MERCURY: 1991-1993 CAPRI

Water leaks around the “A” pillar area may be caused by the windshield header weatherstrip.

Article No. 94-7-3 Cont'd.

Figure 1 - Article 94-7-3

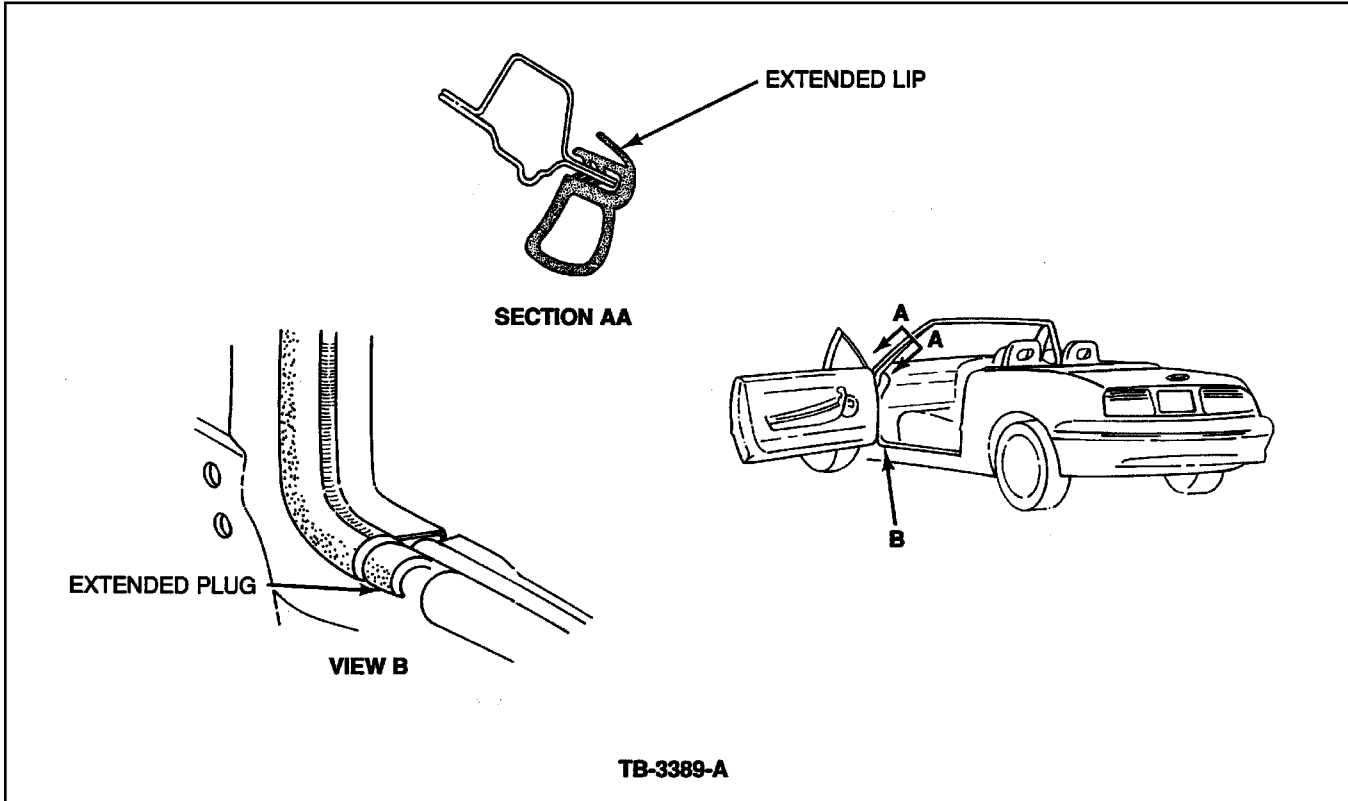
The new level windshield header weatherstrip provides improved sealing with the following features, Figure 1:

- An extended trim lip along the “A” pillar section to eliminate gaps
- An extended plug in the ends of the weatherstrip (where the weatherstrip joins to the door weatherstrips) to eliminate water leakage caused by weatherstrip “puckering”

A revised windshield header weatherstrip is now available which will provide improved sealing in the “A” pillar area.

Figure 2 - Article 94-7-3

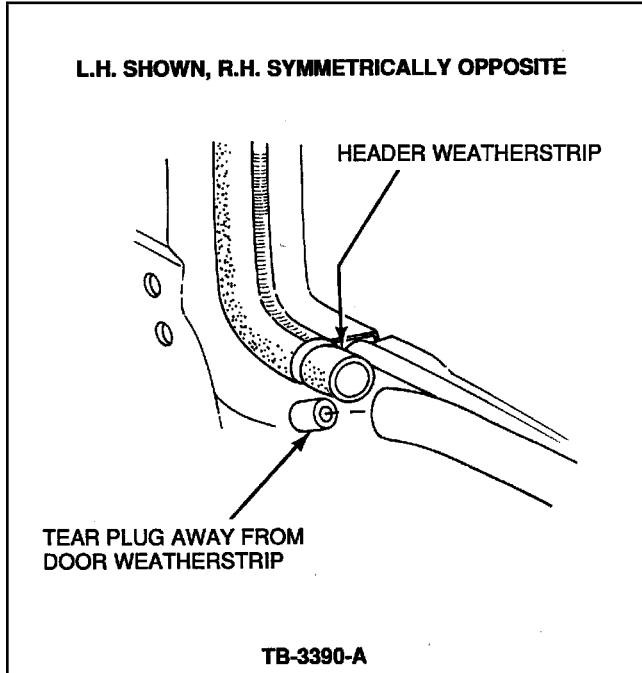
1. Remove the header weatherstrip.
2. Tear plug away from the ends of door weatherstrips, Figure 2.
3. With the windshield header weatherstrip removed:
 - a. Peel away any double-sided tape from the horizontal and vertical faces of the windshield moulding.

Figure 3 - Article 94-7-3

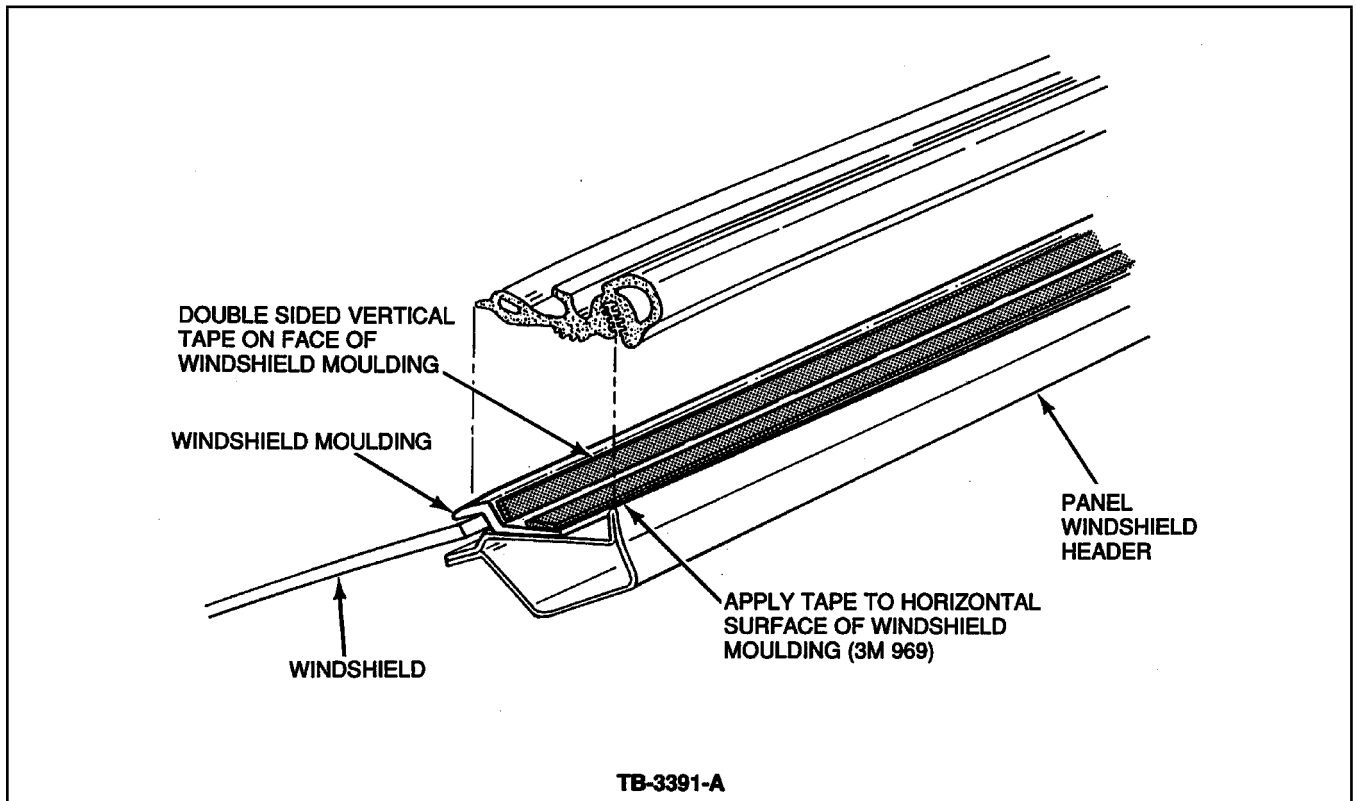
4. Apply the new tape (F2JY-76514-A46S) to the front vertical face of the windshield upper moulding. Press tape firmly to ensure full contact. **DO NOT** remove pull tape.
5. Apply a strip of 3M Brand '969' adhesive tape (FOJY-76514-A46A, or equivalent) along the length of the horizontal face of the windshield upper moulding. Do not peel the backing paper from the tape, Figure 3.
